The Republic, Mayfield Manchester
Planning Addendum Report
0197_MAY-MCO-M01-XXXX-RP-A-090080
Rev: P03
Ref: A283-10.01-148
November 2024

1.0 Planning Addendum

1.1 Introduction

2.4 Fifth Floor to Sixth Floor Plan

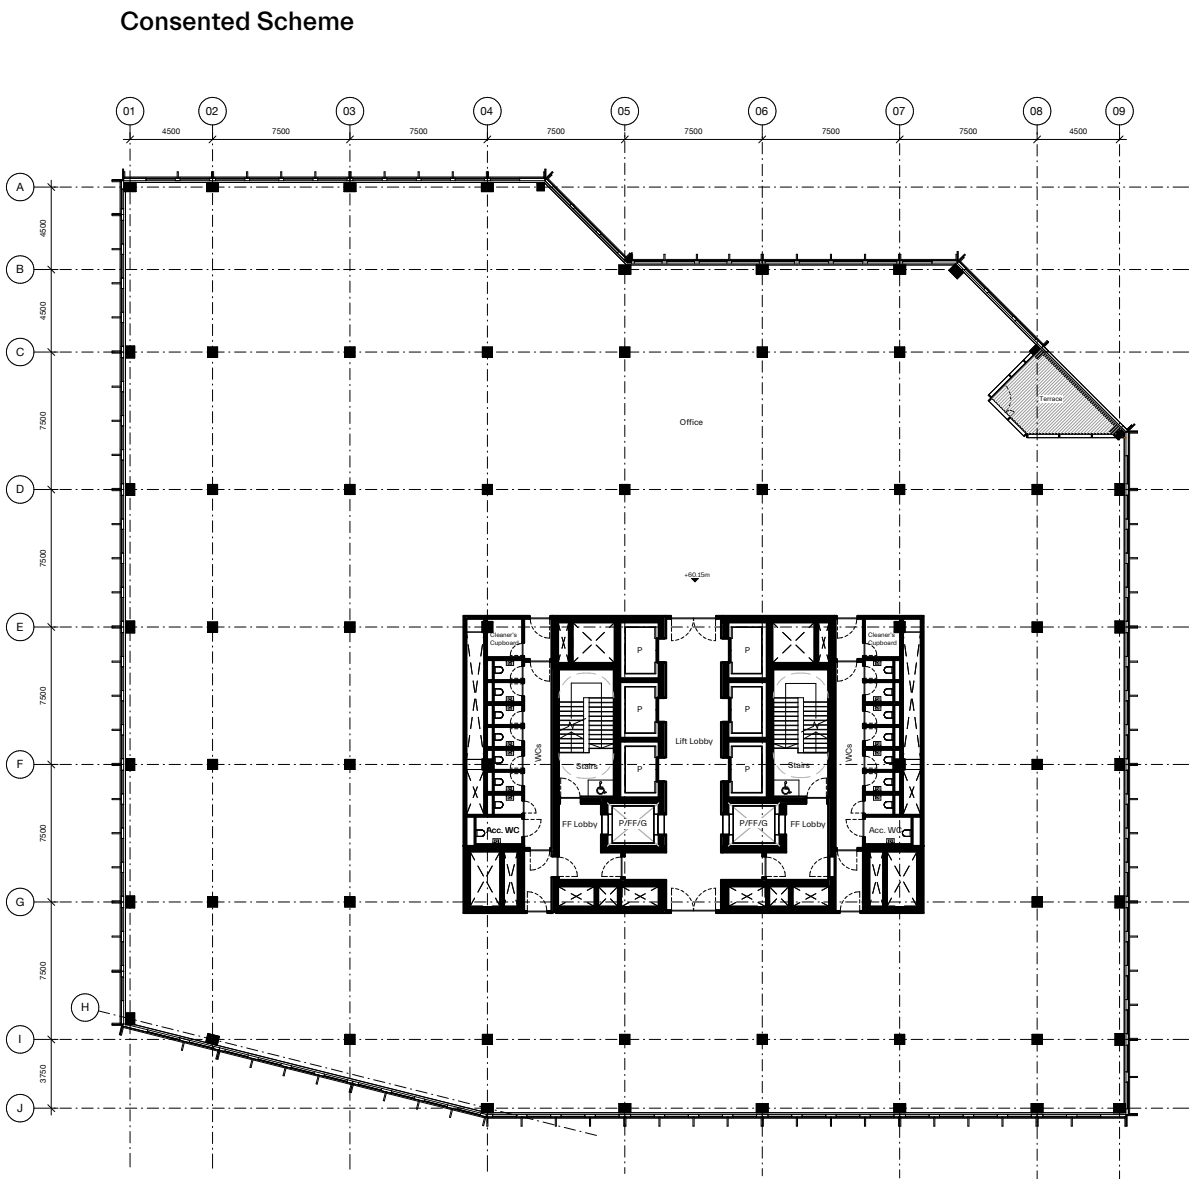
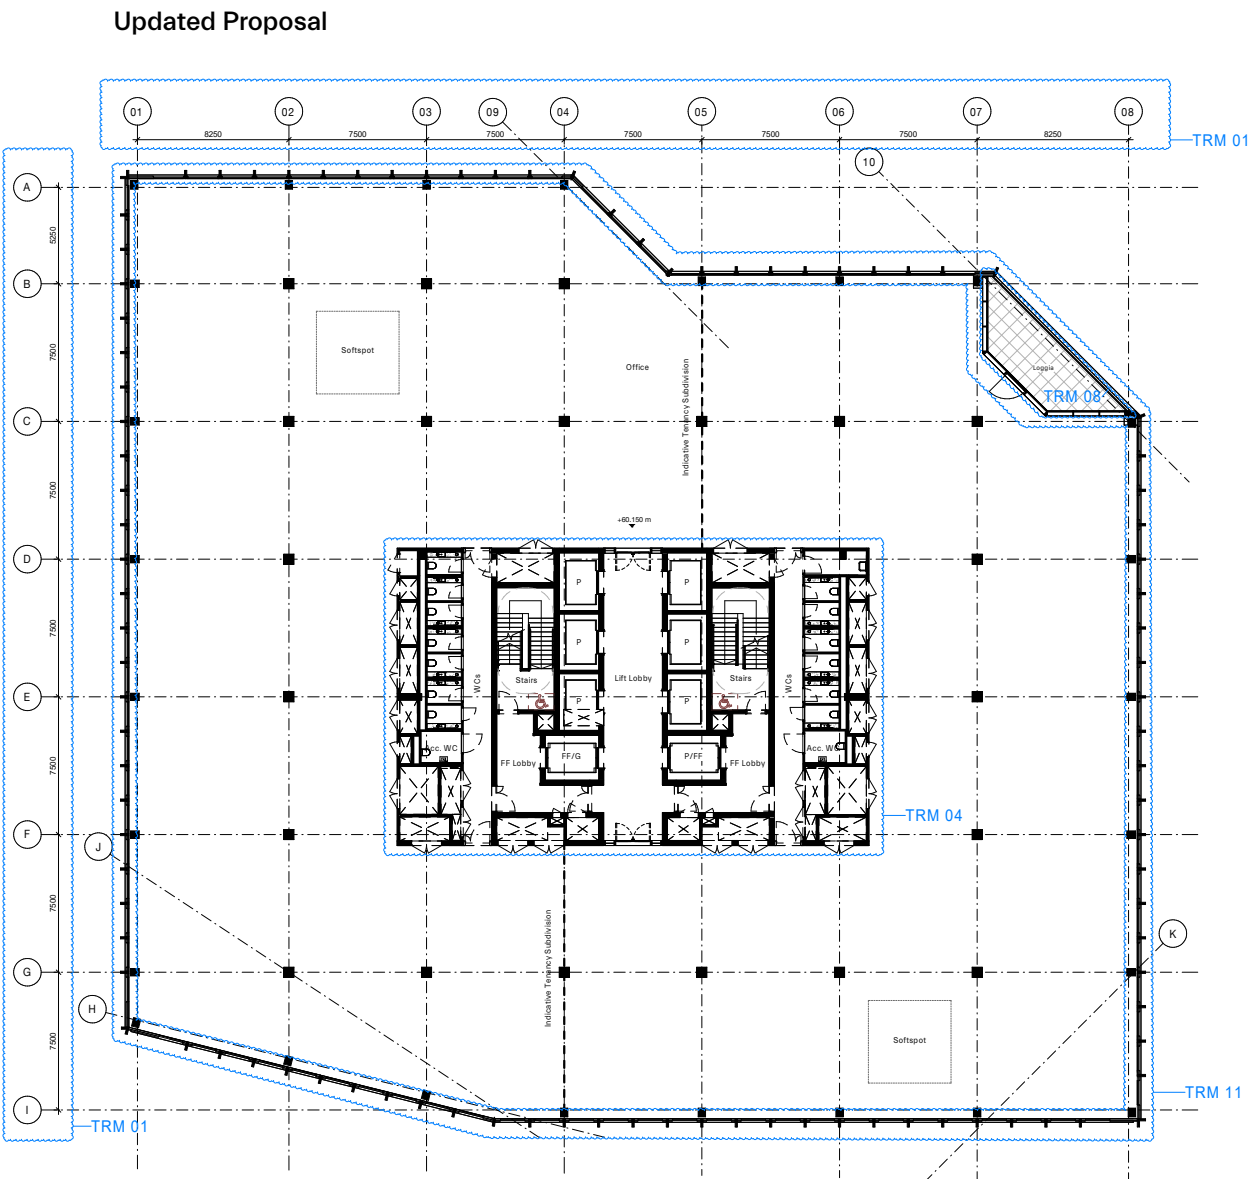
- + TRM 01 - Structural Grid
- + TRM 04 - Core Position
- + TRM 08- External Amenity Space
- + TRM 11 - Facade Development

2.5 Seventh Floor Plan

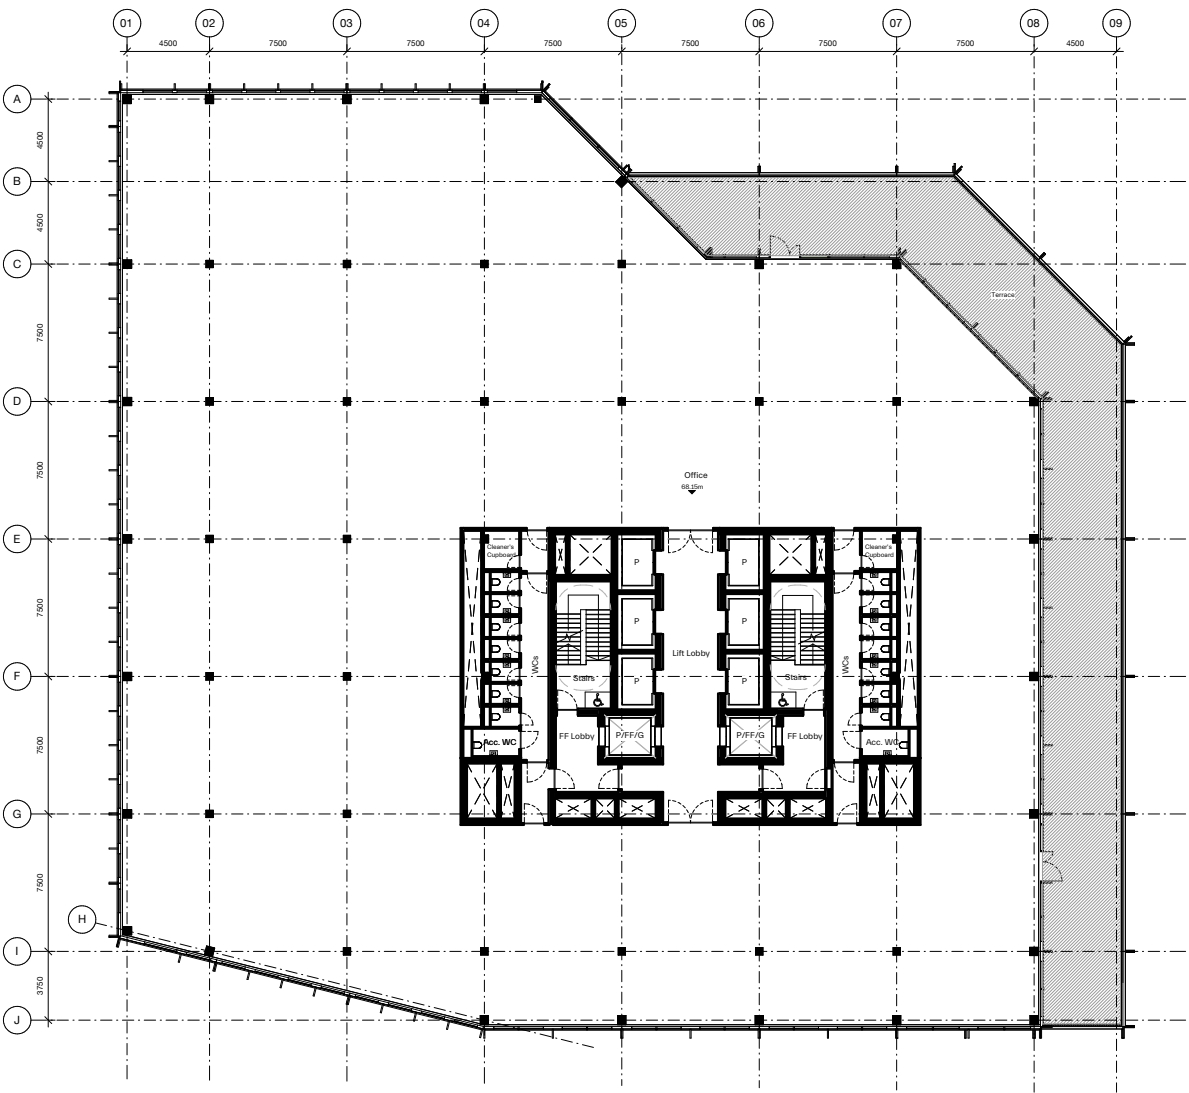
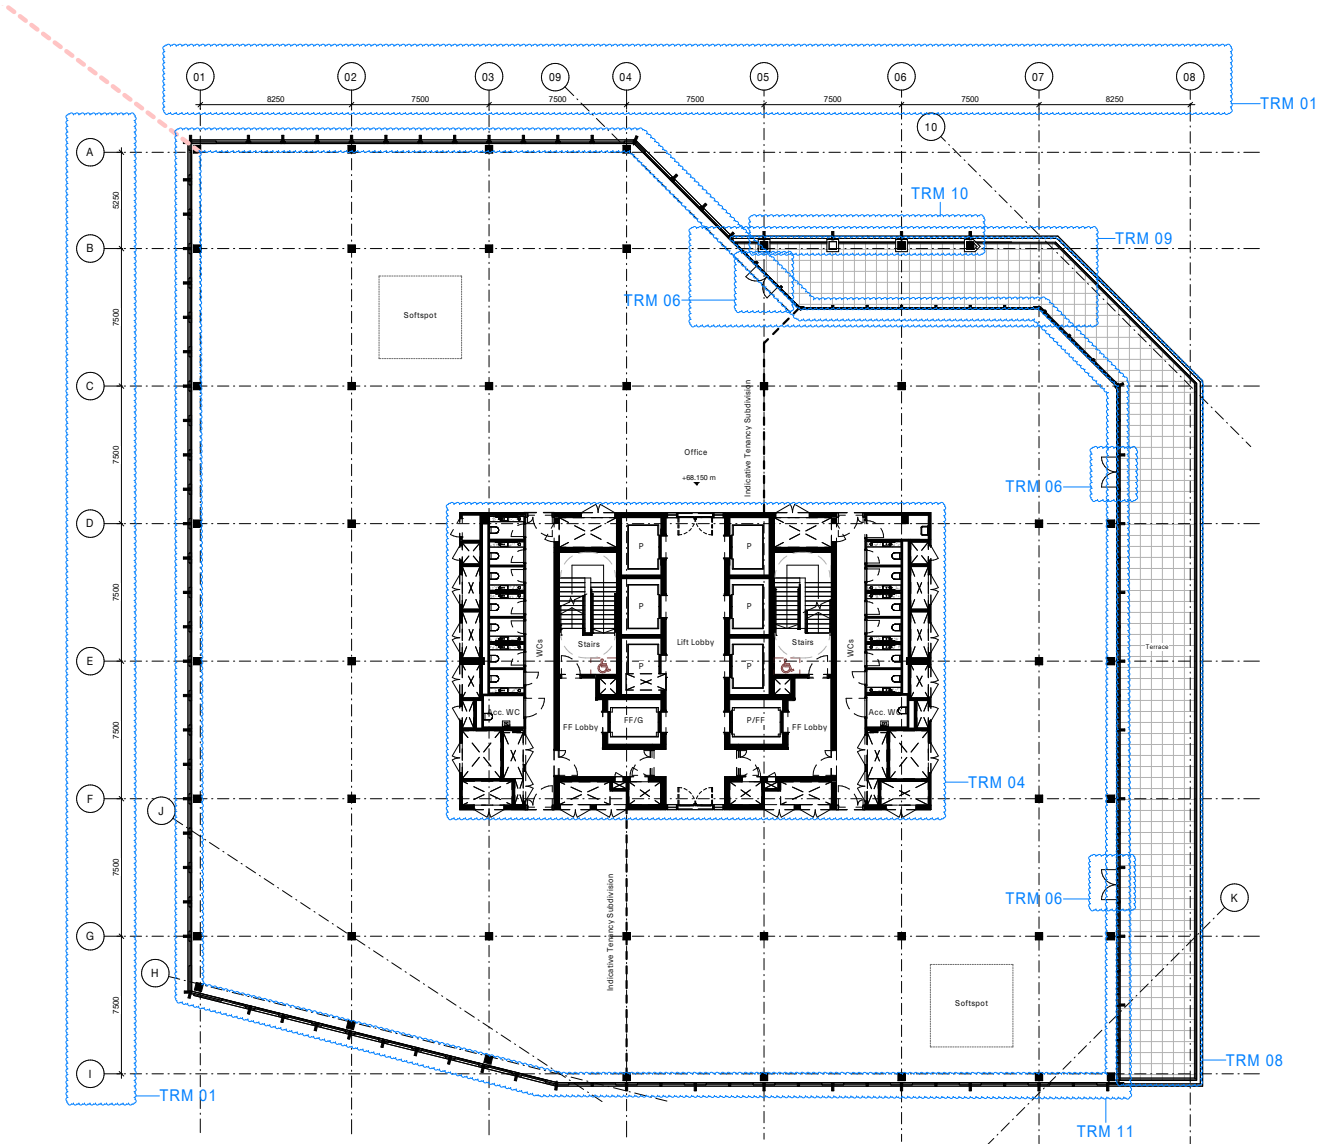
- + TRM 01 - Structural Grid
- + TRM 04 - Core Position
- + TRM 06 - External Doors
- + TRM 08- External Amenity Space
- + TRM 09 - Massing to North
- + TRM 10 - External Columns
- + TRM 11 - Facade Development

2.6 Eighth Floor to Ninth Floor Plan

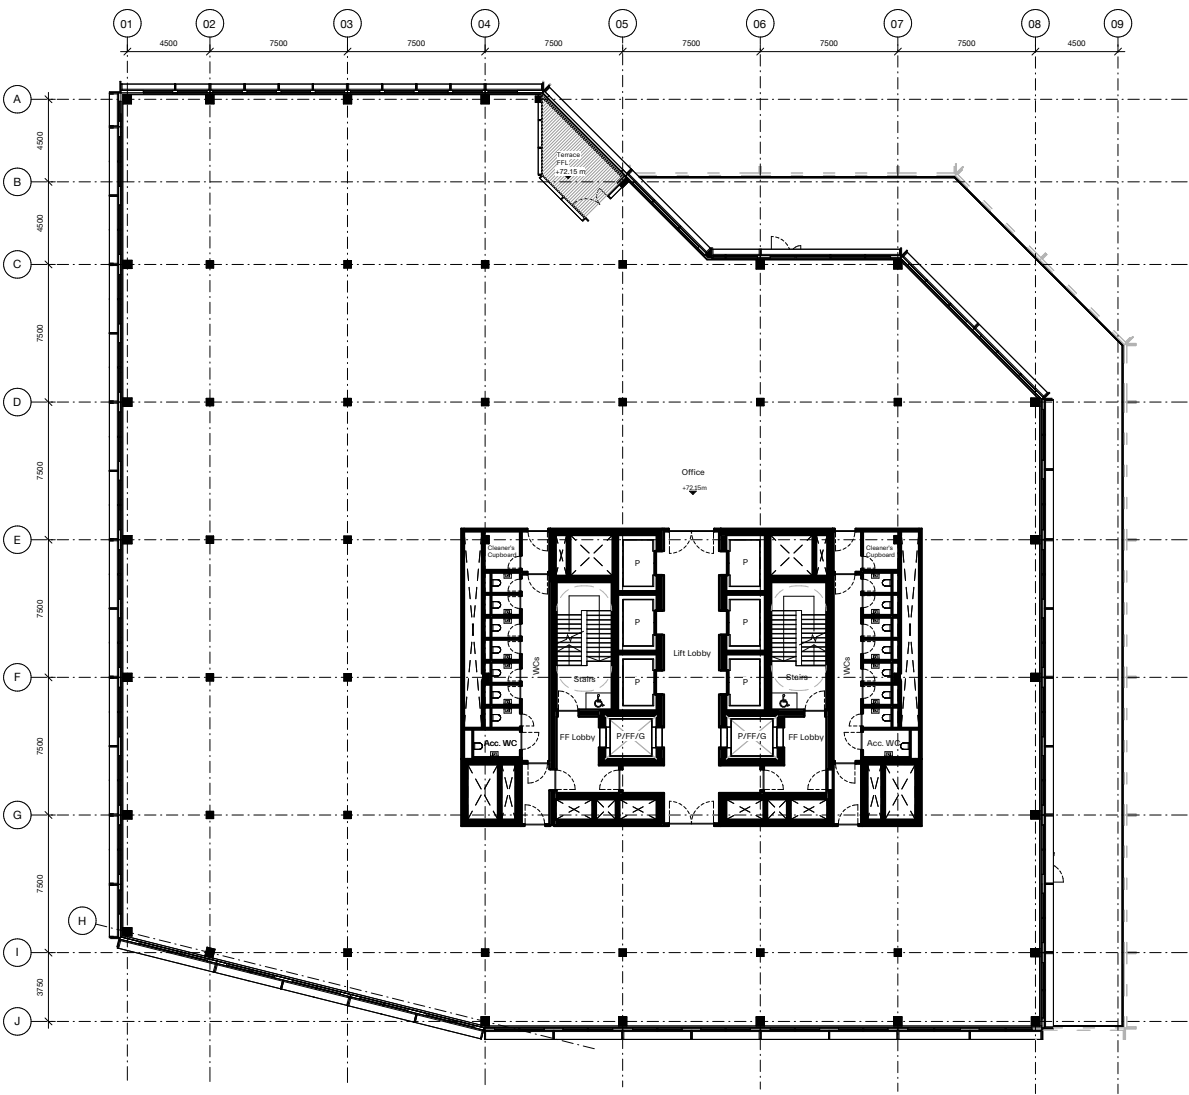
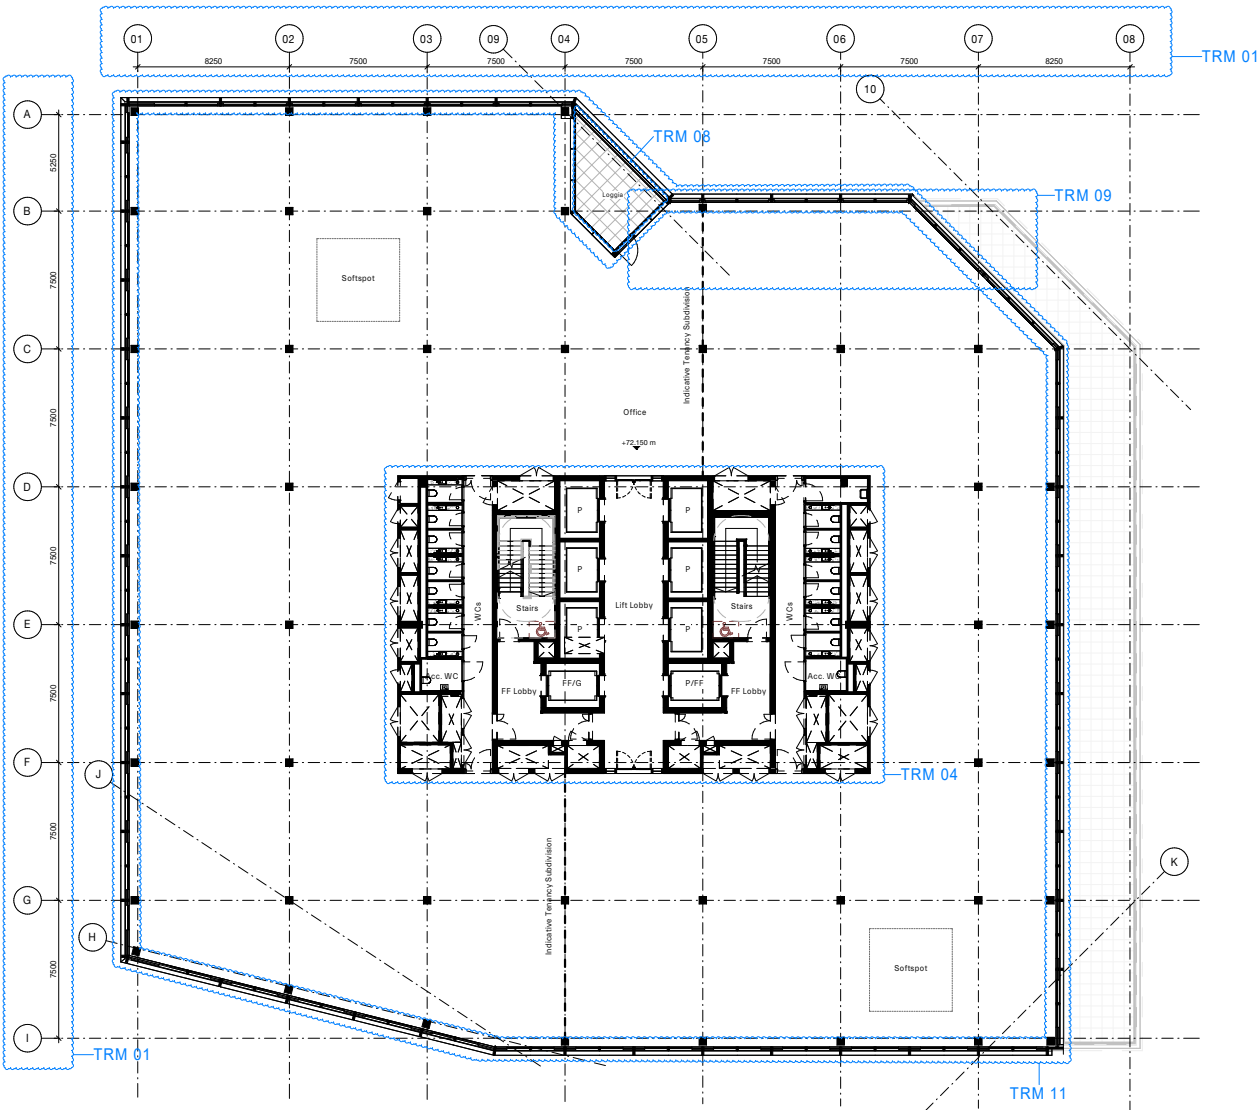
- + TRM 01 - Structural Grid
- + TRM 04 - Core Position
- + TRM 08- External Amenity Space
- + TRM 09 - Massing to North
- + TRM 11 - Facade Development

2.7 Tenth Floor Plan

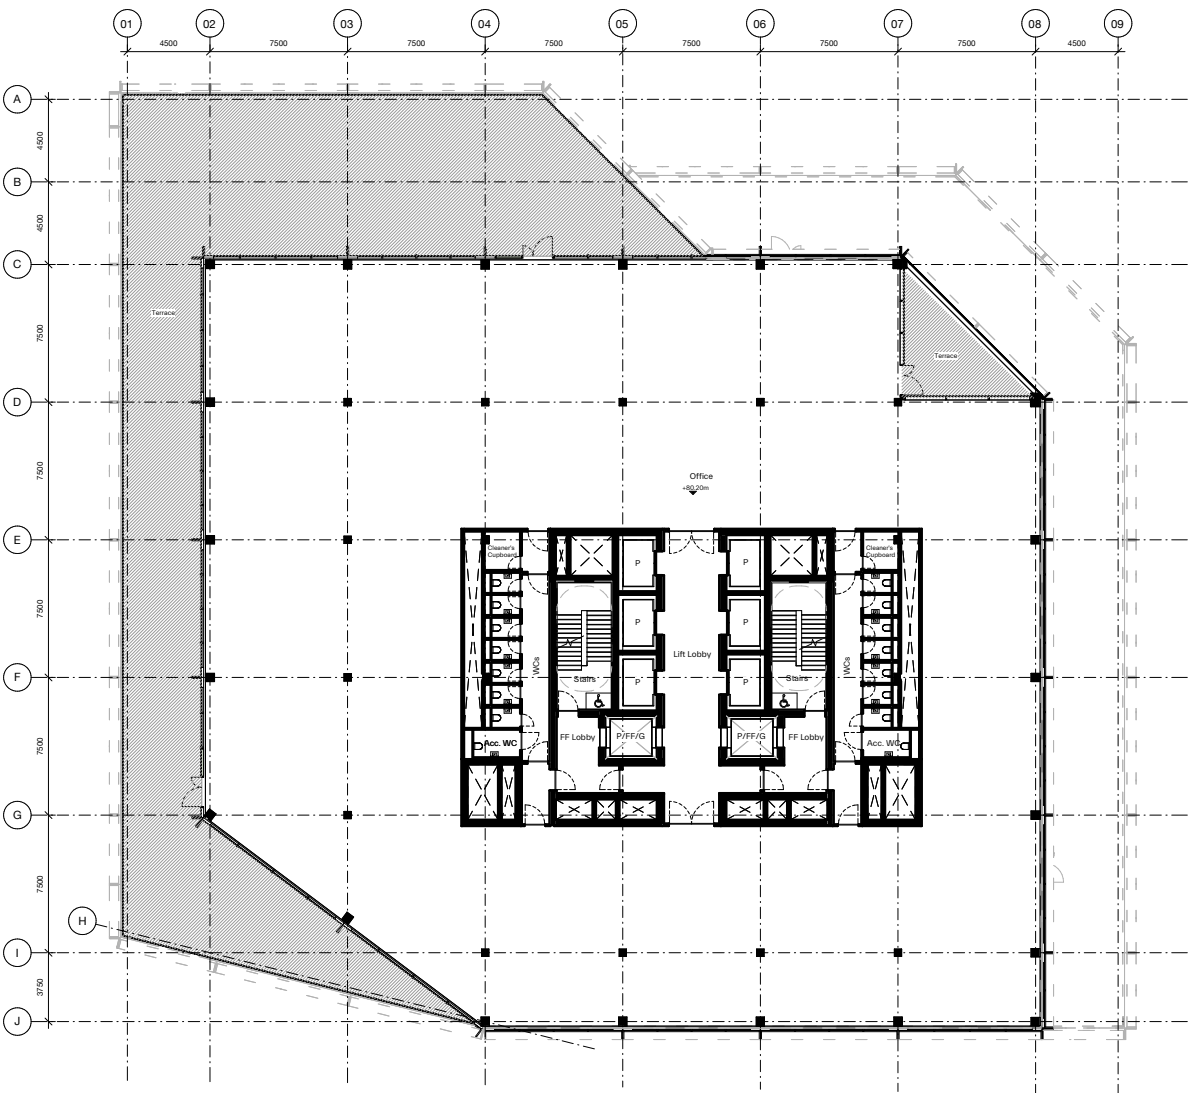
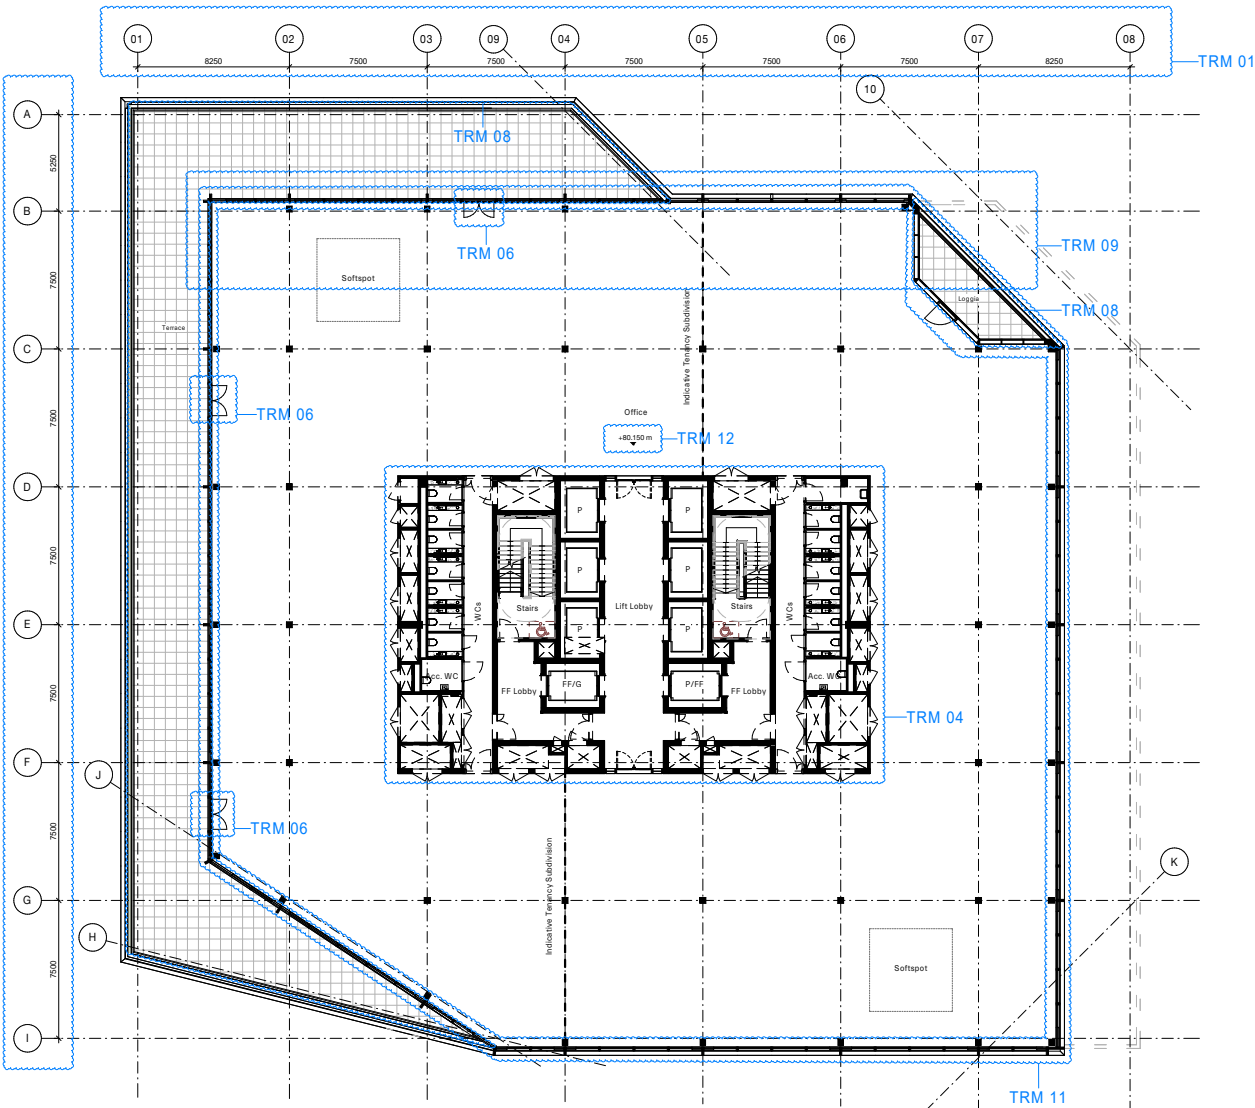
- + TRM 01 - Structural Grid
- + TRM 04 - Core Position
- + TRM 06 - External Doors
- + TRM 08- External Amenity Space
- + TRM 09 - Massing to North
- + TRM 11 - Facade Development
- + TRM 12 - FFL
